TO: Luis Pereira, City of Saint Paul
FROM: Ben Palazzolo, Alliant Engineering Inc.
DATE: 2-4-21
SUBJECT: Re: Zoning File No: # 20-102-583 Preliminary Plat approval for Highland Bridge Rowhomes Second Addition

- FIRE TRUCK ACCESS
- FIRE TRUCK ACCESS (PRIVATE PROPERTY)

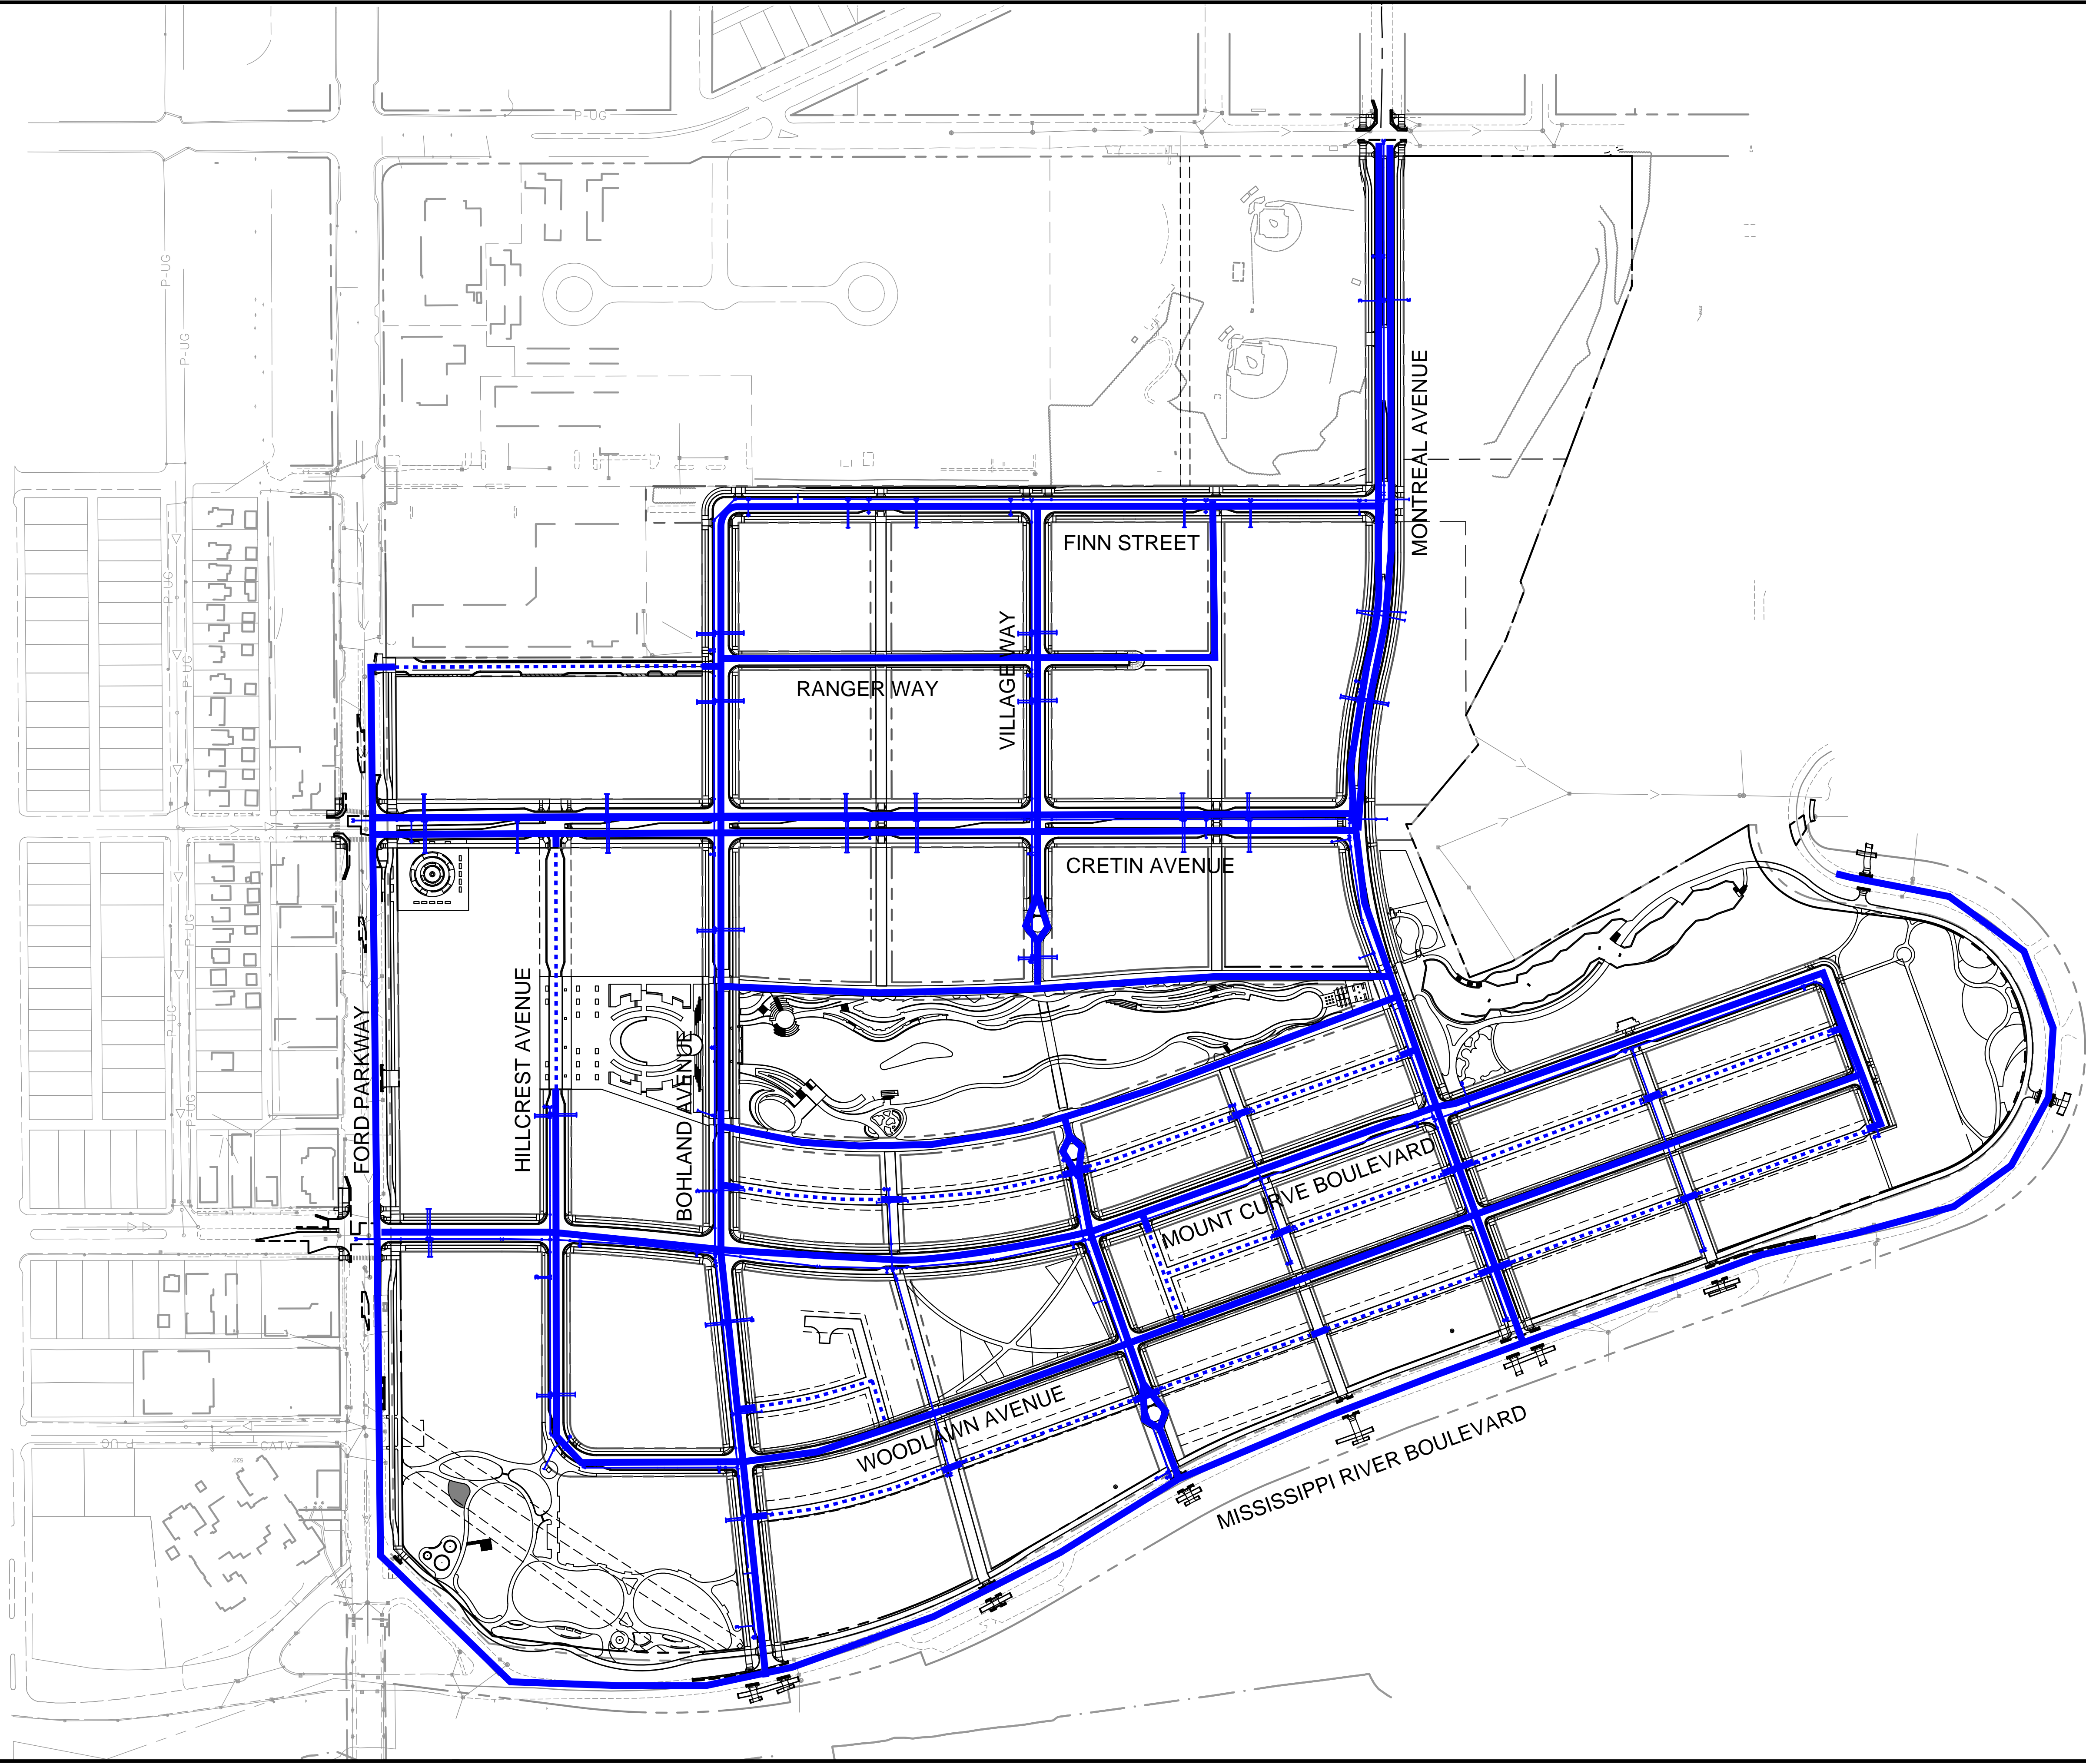
- Fire noted that adding another townhome and connecting the buildings will change the fire access on the site. Mount Curve Boulevard, Village Way, and Falls Passage East are all fire access lanes, but Beechwood and the alleys are not. The fire truck should be able to park within 150 feet of all parts of the building. These are more proactive comments and a detail that Fire will look for in detail when site plans are submitted.

Ryan Companies has revised Exhibit 26 Fire Truck Access to add all rowhome alleys as fire access drives. This exhibit had not been updated since the rowhome neighborhood had been designed. Since the beginning of review of the rowhome area, fire access through the alleys had always

been planned and designed for. The exhibit was out of date.
